Professional Audio Service Bulletin

SUBJECT: Signal Electronics PC Board FET Replacement

APPLICABLE TO: All M-79 Signal Electronic PC Boards which use Motorola FET'S

APPLICABLE TO: ALL M-79 Professional Audio Recorders

FIGURE 1

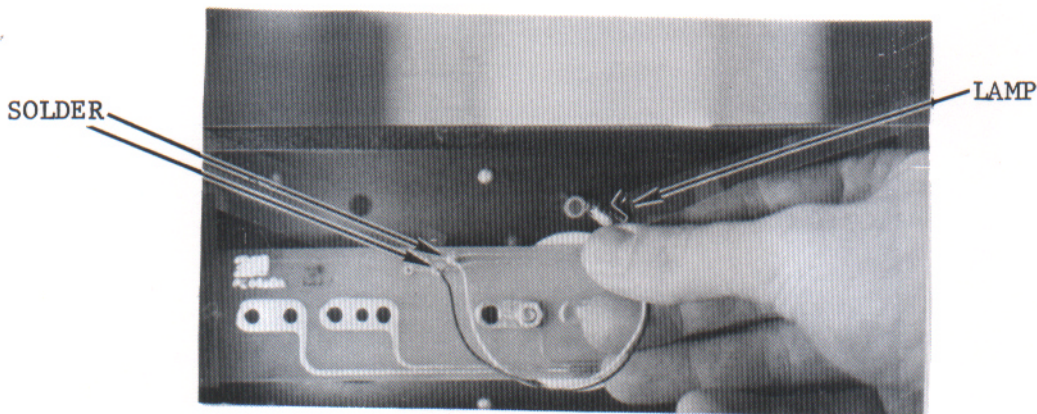
- I. Remove MURA type meter lamp from the white line cap above the meter and unplug the wires from meter mother board.
- II. Solder wires on lamp holder 83-1620-0294 in place of the removed wires on the mother board (see Figure 1).

- III. Insert the lamp, type 388, in holder (83-1620-0294) and insert entire assembly in the white lens cap.
- IV. Future replacement of failed lamp will be accomplished by replacing the lamp only.

FIGURE 1

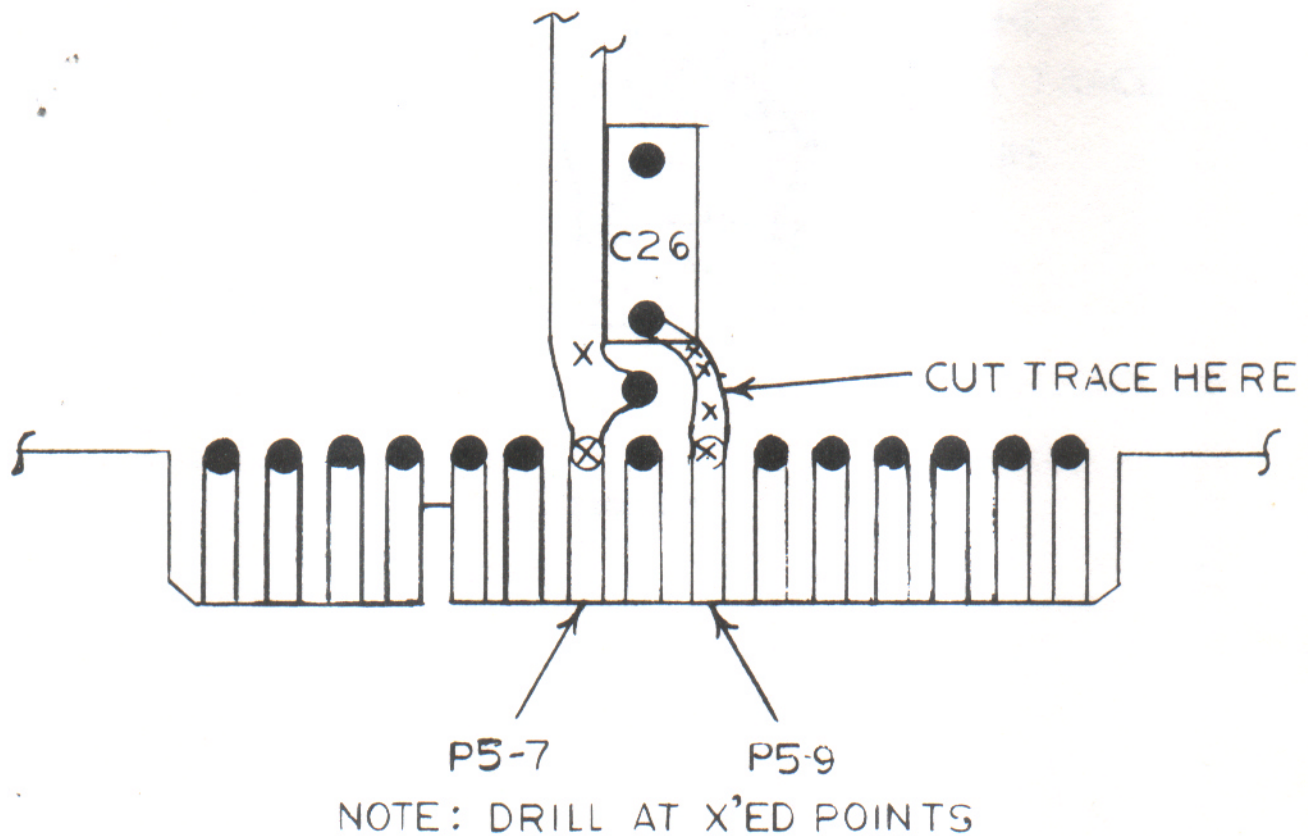
- 1) Remove all power from machine.
- 2) Remove the following from Logic and Master Bias Supply PC Board in sequence:
 - a) Connectors
 - b) 2; 6-32 Hold Down Screws
 - c) PC Board from machine.
- 3) Place board on bench component side up and three connectors facing toward you.
- 4) Locate P-5. It will be to the extreme right of the board. Locate contact 9 and note that trace runs from contact 9 to the bottom side of C-26. Cut this trace.

- V. Utilizing the drill motor and the #70 twist drill, put 6 holes thru the PC Board. Location of these holes are as follows: (See Figure I)
- A. Top of Contact Finger #9
 - B. Top of contact Finger #7
 - C. Between contact Finger #9 and cut in trace.
 - D. In trace running to the left of C-26 near lower left hand edge of C-26.
 - E. Between cut in trace and bottom of C-26, drill 2

FIGURE 2

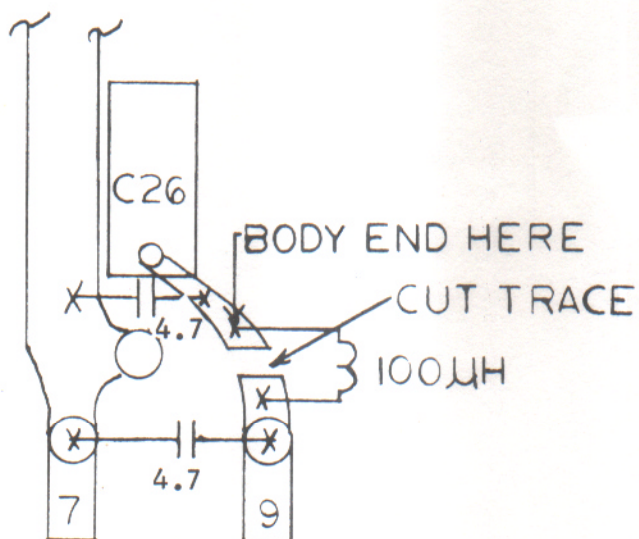
- VI. Install 4.7uf capacitor between holes drilled at top of contacts 7 & 9.
(See Figure 2)
- VII. Install 4.7uf capacitor between holes drilled just below and to the left and right of C-26. (See Figure #2)
- VIII. Install 100μh coil in two remaining holes (See Figure 2)
